Product Safety Notice – Evolution Floodlight

Full description of problem

figure 3

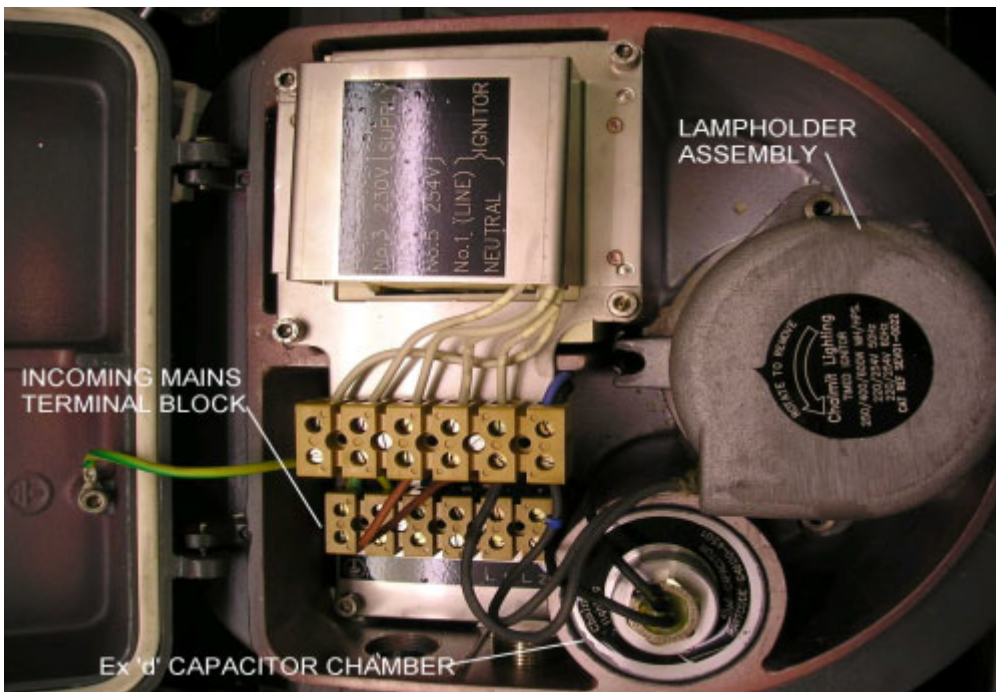
The Chalmit Evolution has an Ex'e' chamber at one end of the luminaire. This chamber contains the mains incoming terminals, the ballast and electrical connections. It also affords access to the lampholder assembly and the power factor correction capacitor which is enclosed within an Ex'd' chamber. See figure 3 below.

Under certain conditions the power factor correction capacitor can fail within its Ex'd' screwed flame path enclosure inside the Ex'e' chamber. The most likely cause of failure is thought to be abnormal voltage conditions out-with the specified operating parameters. Extensive testing has been carried out on both new and aged capacitors under laboratory conditions and the results are consistent with this theory.

Luminaire Wattage	Capacitor Value	Replacement Partcode
150W	20uf	PEVOC-0001
250W	30uf	PEVOC-0002
400W	40uf	PEVOC-0003
6. Remove the existing capacitor assembly from the Ex'd' chamber using an adjustable spanner/wrench and inspect chamber.

7. Screw the replacement capacitor assembly into the Ex'd' chamber until hand tight. Using a suitable spanner/wrench tighten the assembly a further quarter turn clockwise.

figure 6

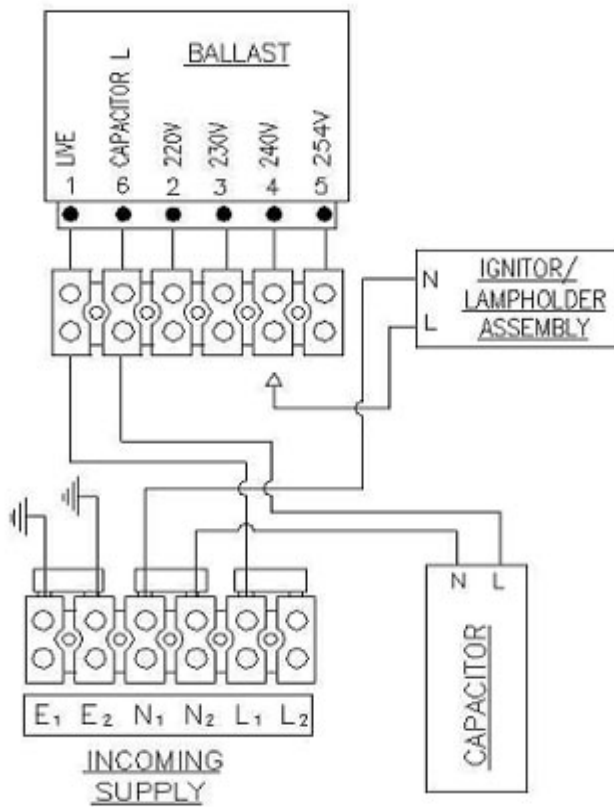
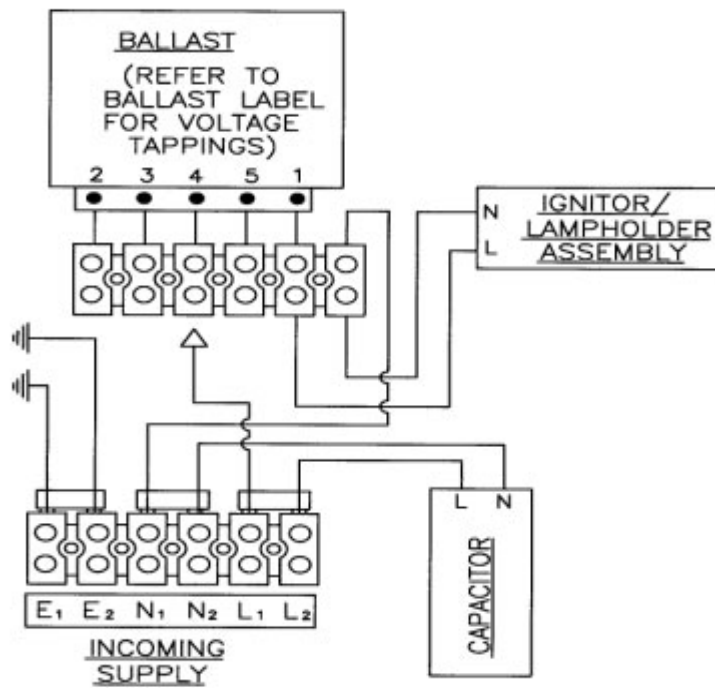
8. Connect the capacitor cables to the live and neutral terminals as shown in figure 6.
(Note: different wiring arrangements are employed depending on the ballast type. This can be easily identified with reference to the wiring diagrams in figure 6.)

- a) Disconnect the two capacitor cables from the relevant terminals ensuring that the terminals are properly tightened after removal.
 - b) Using an appropriate tool cut the capacitor cables as close as possible to the capacitor cap and remove the cables.
